BOUM USER MANUAL ADDENDUM
OTO Machines - January 2024

BOUM REVISION 1.3 (January 2024)

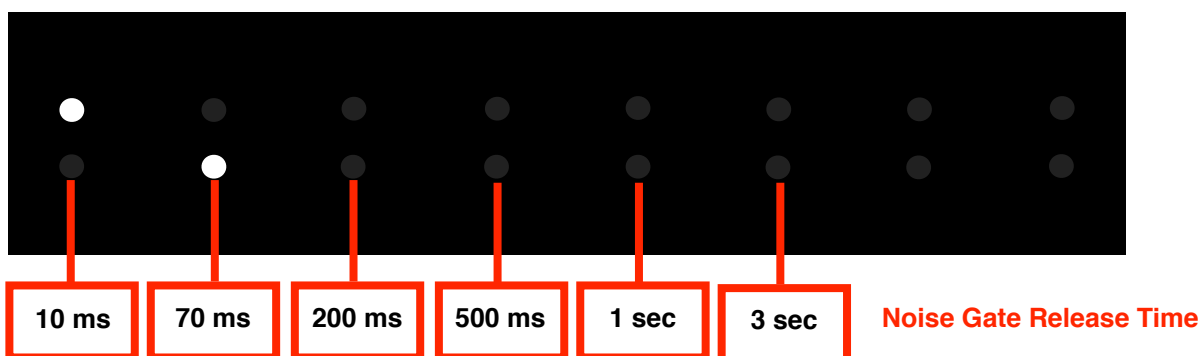
1. NEW FEATURE :
You can dim the brightness of the 8 switches.
Press RELEASE switch while powering BOUM on.
The DATA pot now controls the brightness in 4 steps.
When you are ok with the brightness, swicth BOUM off and on.
This setting is kept in memory.
The brightness dim function is not applied on the submenus (Display mode, Local mode, …), the Preset save mode and the MIDI menu.
